1. ENTRY GATEWAY FEATURES:

MUNICIPAL GUIDELINES:

CITY OF KIRKLAND
Planning and Building Department
123 5th Avenue, Kirkland, WA 98033
425.587.3600 ~ www.kirklandwa.gov

7. PEDESTRIAN COVERINGS:

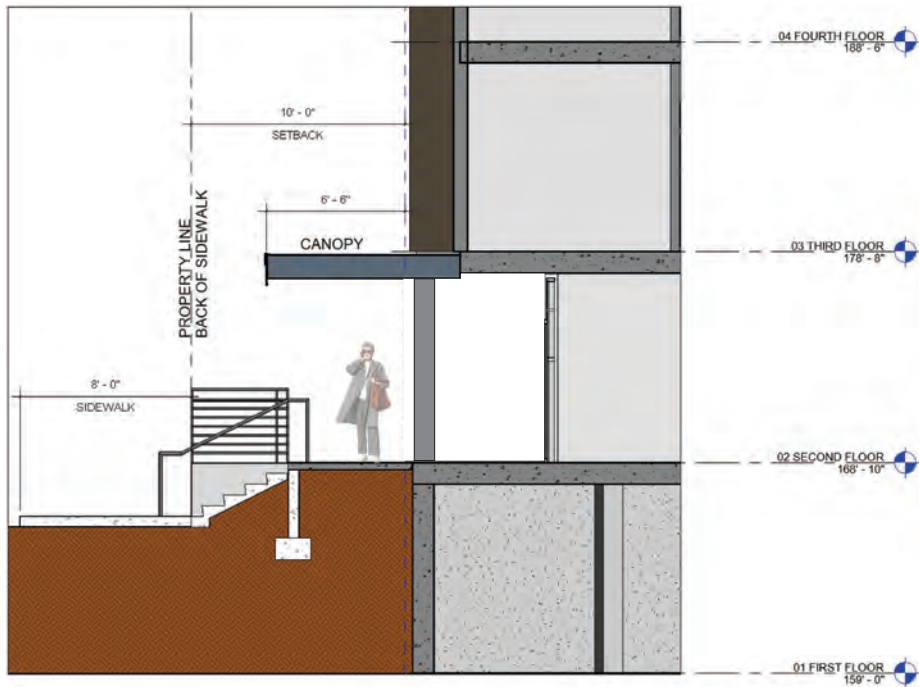
Note that we are requesting a deviation to extend the canopy 6'-6" feet into the 10' setback to provide better coverage for the ramp and stairs from the sidewalk to the primary entrance.

As noted in the Staff Memo and at the September 12th Meeting, a deviation or modification is not needed for the proposed canopy is allowed to extend into the required setback yard per code.
